TECHNICAL INSTRUCTIONS

X4 7300 & 7500 SAS HARNESS REROUTE

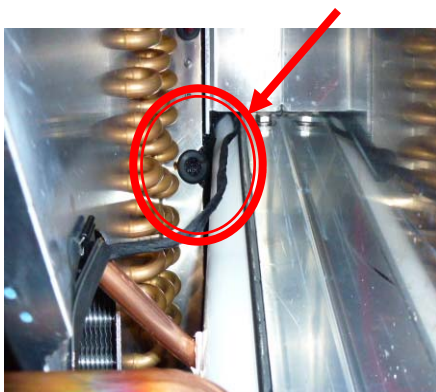
It has been determined that Carrier Transicold X4 units, models 7300 and 7500, in the serial number range PAX91377926 through PAX91378858 require the supply air sensor (SAS) harness to be rerouted. Failure to reroute this harness could lead to chaffing of the wiring harness, potentially causing failure of the SAS. Failure of the SAS could affect the unit temperature control.

Missed routing wire through grommet

1. Ensure the unit will not start automatically by disabling any two way communication and placing the units On/Off switch in the off position. Disconnect the Negative battery cable.
2. Remove Evaporator panel
3. Remove the Prestite tape securing the SAS harness where it is routed through the evaporator coil.
4. Reroute the SAS harness through the grommet (see pictures below).
5. Re-secure the Prestite tape to prevent any movement of the SAS harness.
6. Reinstall evaporator panel.
7. Reconnect the negative battery cable.
8. Turn unit on, run and check for proper operation.

Proper routing of SAS Harness
